RE: 247-20-001595-EVAL
54735 HUNTINGTON RD, BEND, OR 97707

Deschutes County Environmental Soils Division has reviewed your site evaluation application for an onsite wastewater treatment system on the property identified above. The site was evaluated on November 23, 2020, and was found suitable to install a "System" as defined in Oregon Administrative Rules for Onsite Wastewater Treatment Systems, Chapter 340, Division 71. The approved system for this site requires a nitrogen reducing treatment technology system discharging to a reduced size surface mounted bottomless sand filter system. For more information about the different types of systems, descriptions, design criteria, important links and diagrams, contact our office or visit our website at www.deschutes.org/cd. (Click on the [Onsite Waste Water Treatment Systems](#) link).

SITE EVALUATION FIELD INSPECTION FORM

Sketch/Not to Scale

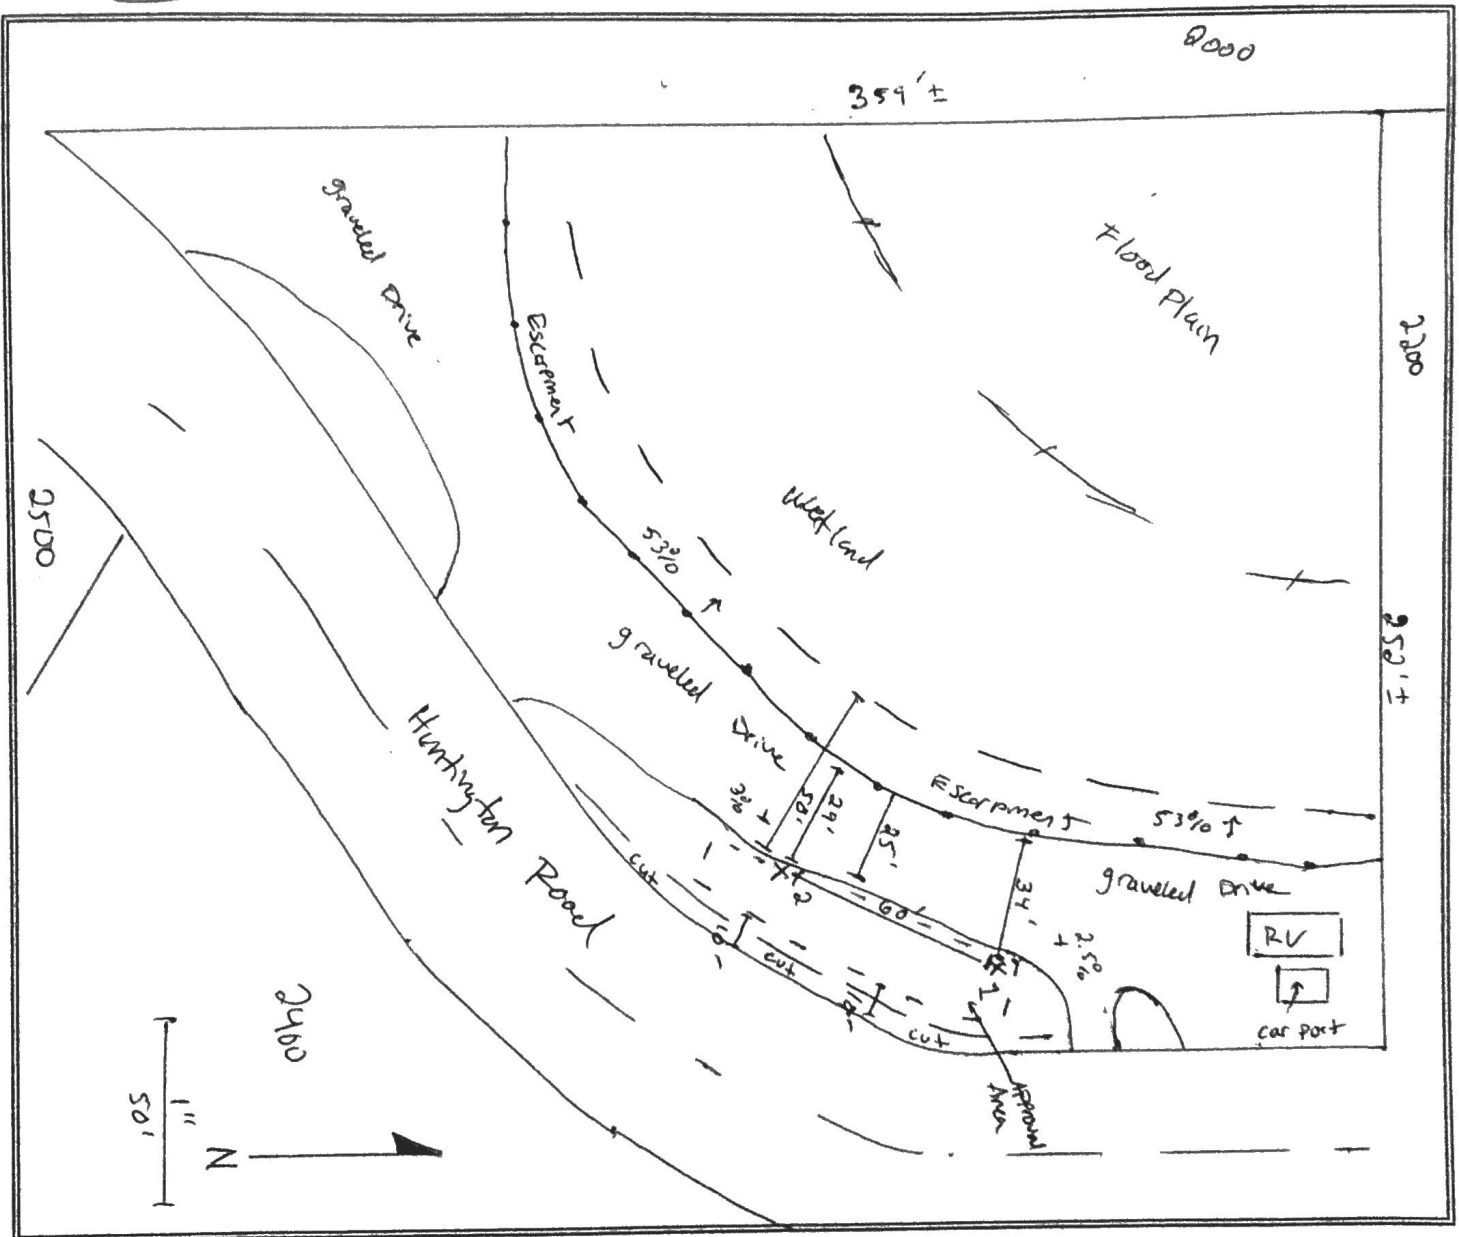
System type approved: ATT to SE

Absorption facility: Bottomless sand filter

Min. Size 250 sq ft Max. Depth 4" Min. Depth 0"

Min. Size 250 sq ft Max. Depth 4" Min. Depth 0"

Tank Size 1200 gallon w/ 500 gallon dosing

Sewage Flow 450 gallons/day

Special Conditions: Maintain setbacks to property lines, wells, underground utilities, etc. There is a 25' setback that applies to the escarpment. A 50 foot setback applies to the wetland. Installation shall take place within the approval area. A sand filter is required due to severe space limitations. The sand filter may be counter-sink 4".
